DEPARTMENT OF TRANSPORTATION**Federal Aviation Administration****14 CFR Parts 25 and 33**

Airplane and Engine Certification Requirements in Supercooled Large Drop, Mixed Phase, and Ice Crystal Icing Conditions

ACTION: Final rule.

FIGURE 1 — Appendix O, Freezing Drizzle, Liquid Water Content

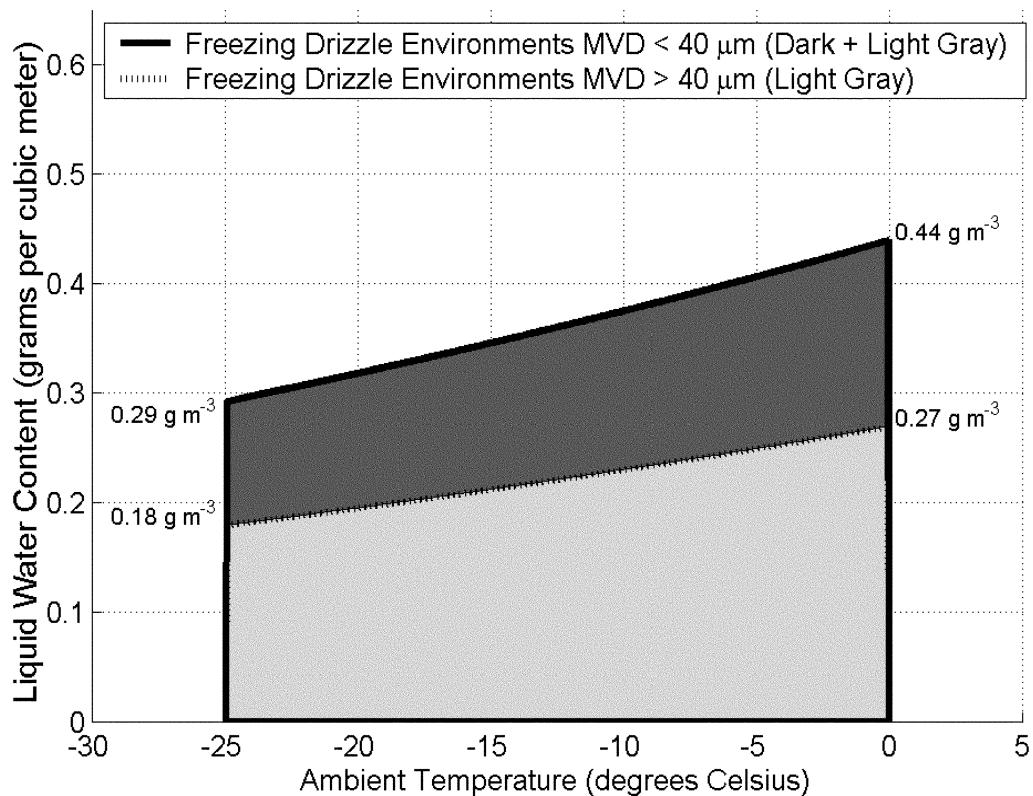
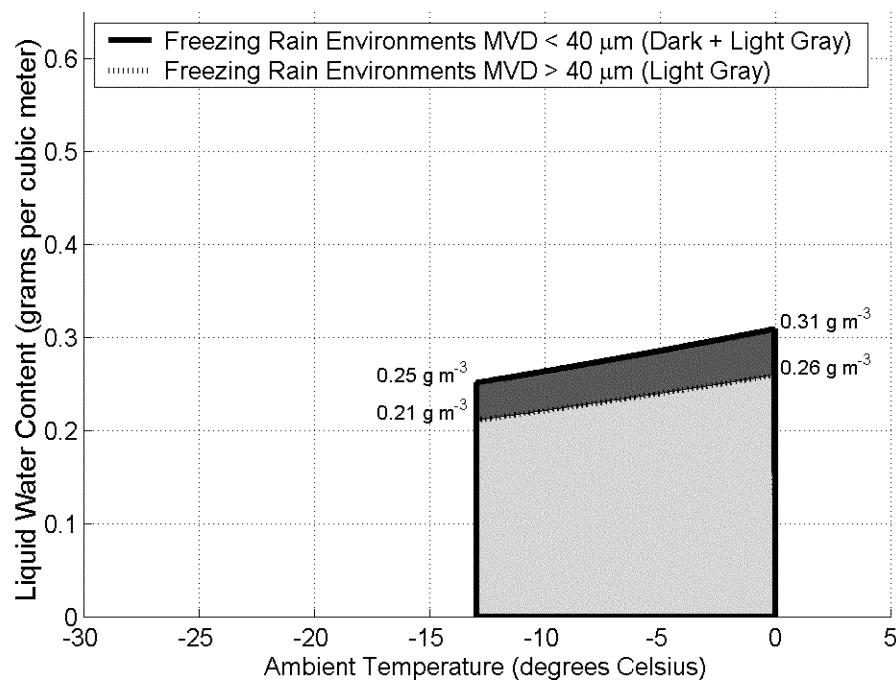
Several commenters said that proposed figures 1, 4, and 7 in appendix O of the NPRM were different than what was proposed by the IPHWG, and that the FAA did not provide an explanation for those differences. The commenters also noted that the higher LWC contained in the figures proposed in the NPRM could have a significant impact on an applicant's design. GSIS specifically noted that the higher water content defined in appendix O will have

In response to other comments, figures 1 and 4 of appendix O have been revised in this final rule to reflect the LWC proposed by the IPHWG. As a result, freezing drizzle conditions with a median volume diameter (MVD) greater than 40 microns fall within the adverse region that would be identified using the University of Wyoming LWC/drop size technique. No changes to appendix O were made as a result of these comments.

We agree. We reviewed the figures proposed in the NPRM and the data used by the IPHWG to generate the figures. We revised figures 1 and 4 to reflect the lower water content values proposed by the IPHWG, but the water content in appendix O is still higher than within appendix C at the same temperature. The higher water content may increase the power requirements for some electro-thermal deicing system designs, but not to the extent that may have been necessary with the water contents proposed in the NPRM. The environmental conditions defined in appendix O are valid conditions that will need to be considered for applicable future designs. Our review of the data used to generate the scaling factor curve in figure 7 indicates that the figure 7 proposed by the IPHWG in the task 2 working group report was incorrect;⁴ figure 7 in the NPRM was correct. Therefore, figure 7 in this final rule remains as proposed in the NPRM. Figures 1, 3, 4, and 6 of appendix O in this final rule have been revised to identify the corner data points for clarity.

FIGURE 6 — Appendix O, Freezing Rain, Temperature and Altitude

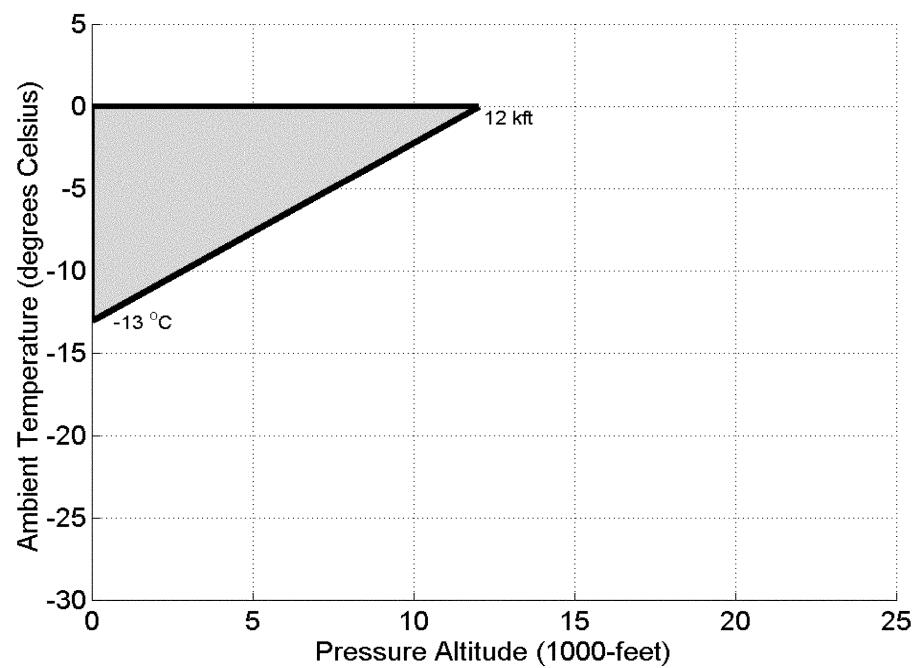
One commenter, a private citizen, noted that the NPRM did not identify the vertical extent for part 25, appendix O, figure 6. We disagree. The pressure altitude range and vertical extent for freezing rain were provided in appendix O, part I, paragraph (b) in the NPRM located under figure 3. We clarified appendix O, part I, by moving all of the general text describing the meteorological parameters, including vertical extent, ahead of the figures.

FIGURE D3 — Exposure Length Influence on TWC

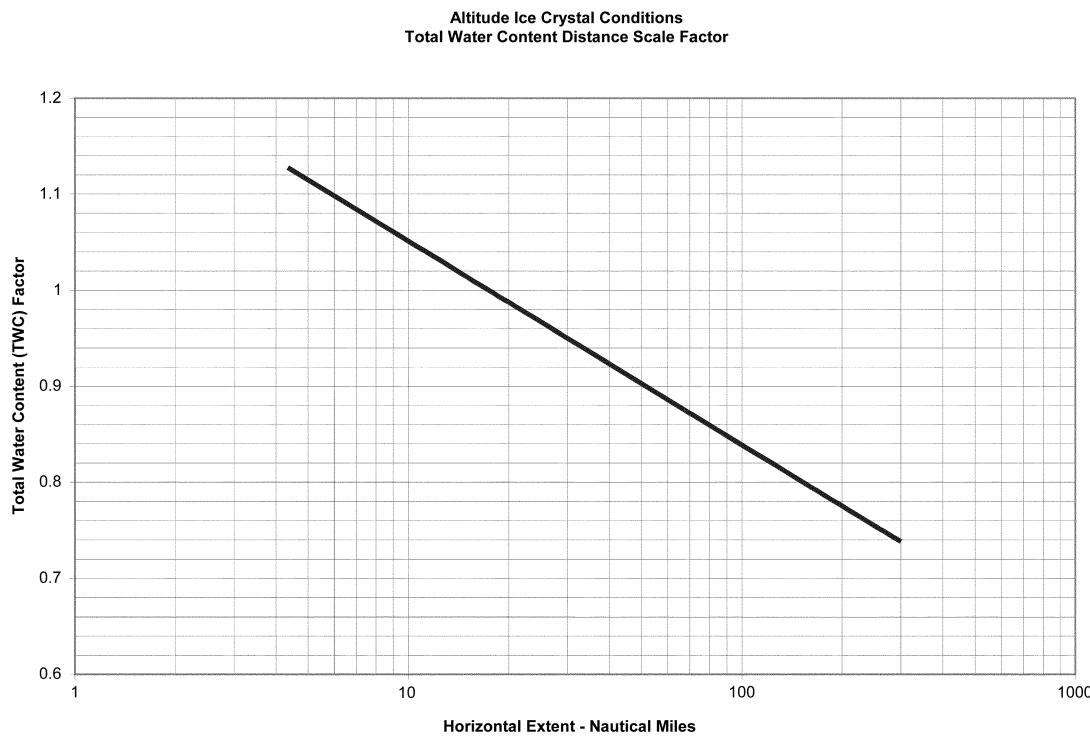
Sncema commented that the y-axis value in proposed part 33, appendix D, figure D3, was incorrect. The value should be 0.6 but the NPRM showed the value as zero.

33, appendix D, figure D3, to depict the correct axis values. The lowest x-axis value is now 1 and the lowest y-axis value is now 0.6.
